**REQUEST FOR INFORMATION      DATE: September 12, 2016      NO.: RFI-280**

Project Name: 15051-Webster University Interdisciplinary Science Building      Project No.: 15051

Subject: Decorative Rail Type 1

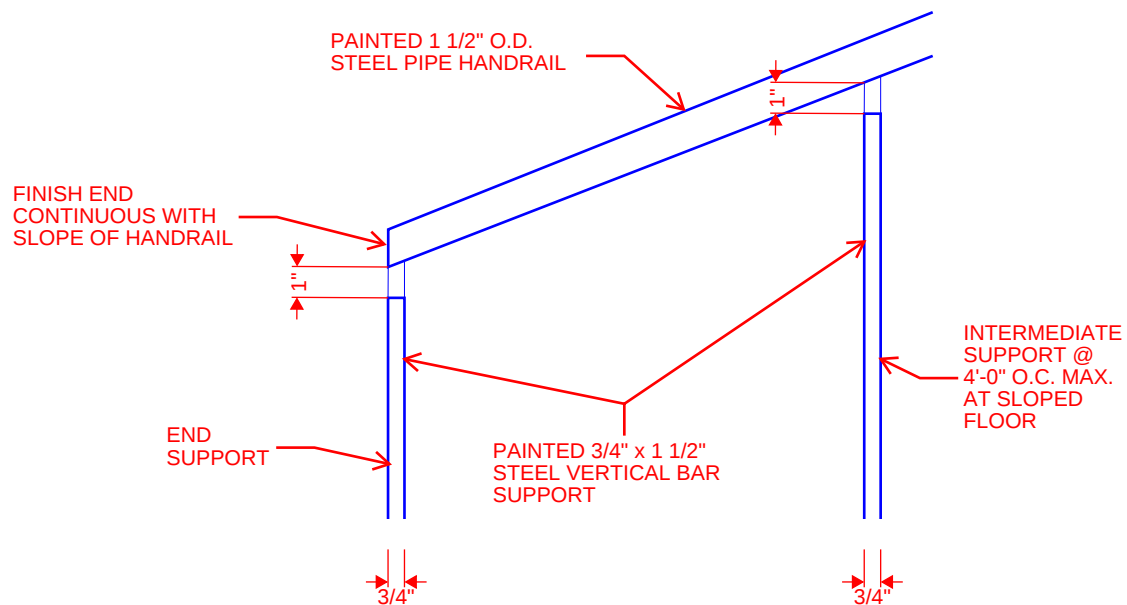
See Detail 2/A0801, this detail calls for the lecture hall rail to be type 1. Please provide information and verify if lecture hall floor mounted rail on Section 9/A0801 is also type 1.

SEE ATTACHED DETAIL SKETCH FOR MORE INFORMATION ON 'TYPE 1' RAILING.

YES, THE FLOOR MOUNTED RAILING IN DETAIL SECTION 9/A0801 & 1/A0801 IS ALSO 'TYPE 1' RAILING.
